STATE OF MAINE
 DEPARTMENT OF HUMAN SERVICES
 DIVISION OF HEALTH ENGINEERING
 10 STATE HOUSE STATION
 AUGUSTA, MAINE
 04333-0010

SUBJECT: Approval, Replacement System Variance Request, St Peter property, Tasker Road, Augusta

REPLACEMENT SYSTEM VARIANCE REQUEST

SUBSURFACE WASTEWATER DISPOSAL SYSTEM APPLICATION

SUBSURFACE WASTEWATER DISPOSAL PLAN

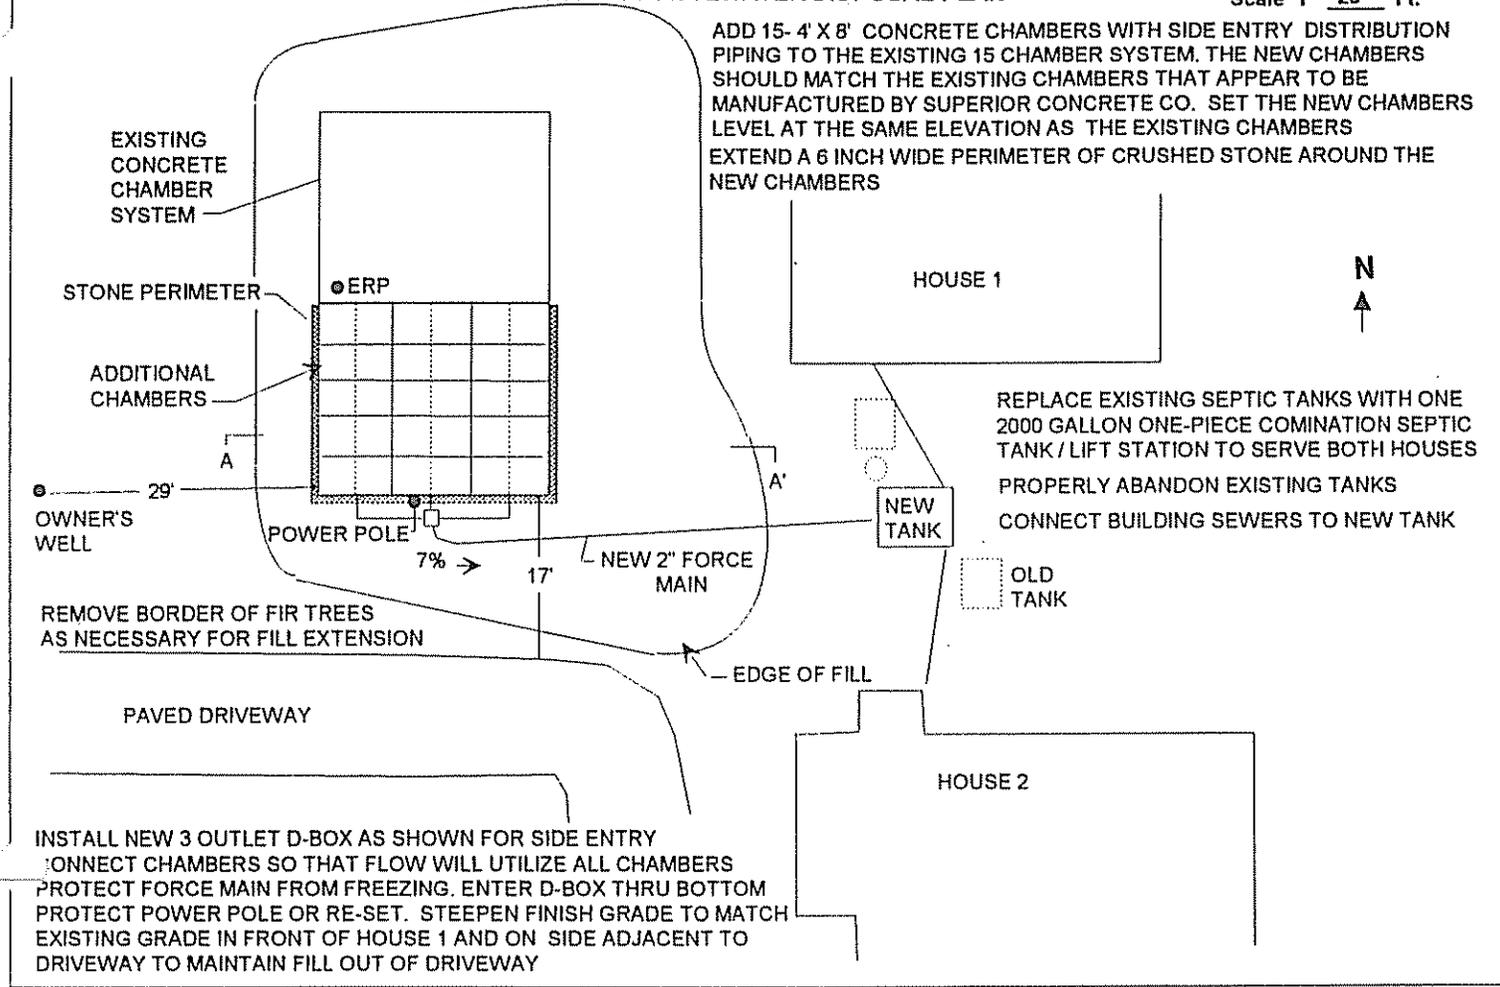
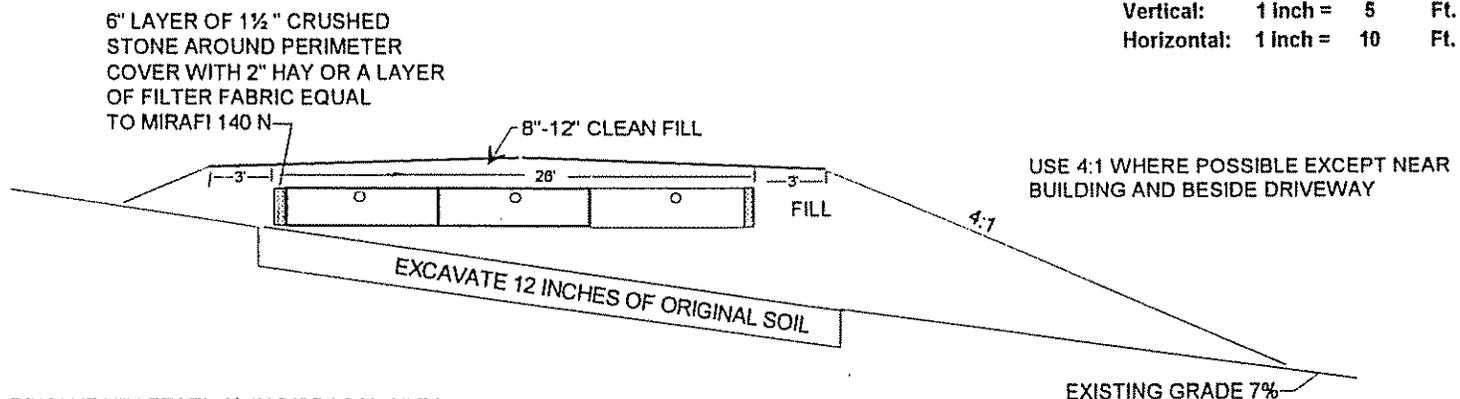
The Division has reviewed a replacement system variance request for the subject property. The state variances requested are to allow the installation of a replacement subsurface wastewater disposal system with a design flow reduction of approximately 29% and a setback distance reduction from the owner's well from the disposal field of 29 feet. Other variances required are reduction in setback distances to the owner's well from the septic tank of 95 feet; a major watercourse from the septic tank of 60 feet; and a fill extension grade to 3:1 where necessary. The system design, prepared by William Brown, SE, dated 10-27-01, replaces the two individual septic tanks serving two separate dwellings with a single 2000-gallon septic tank to be shared by the dwellings. The design is found to be in compliance with the Maine Subsurface Wastewater Disposal Rules.

Your property has some very limiting site conditions, as noted above. The Division generally does not favor extreme setback reductions to drinking water wells. However, given that your property historically has been developed with a year-round dwelling and your options are limited by the site conditions, the Division finds the proposed system a reasonable solution for your property, albeit possibly temporary. We approve the requested variances with the following requirements:

1. A permit for system installation is to be obtained from the Local Plumbing Inspector in advance of the start of system construction.
2. The system is to be installed in accordance with the submitted and approved system design. Should alterations be required at the time of system installation, the system designer must be notified prior to making any changes.
3. The variance approval is based only on the rules administered by this department. The approval of the variance request does not relieve the property owner from compliance with all other state and local requirements pertaining to the installation, use, and operation of the wastewater disposal system.
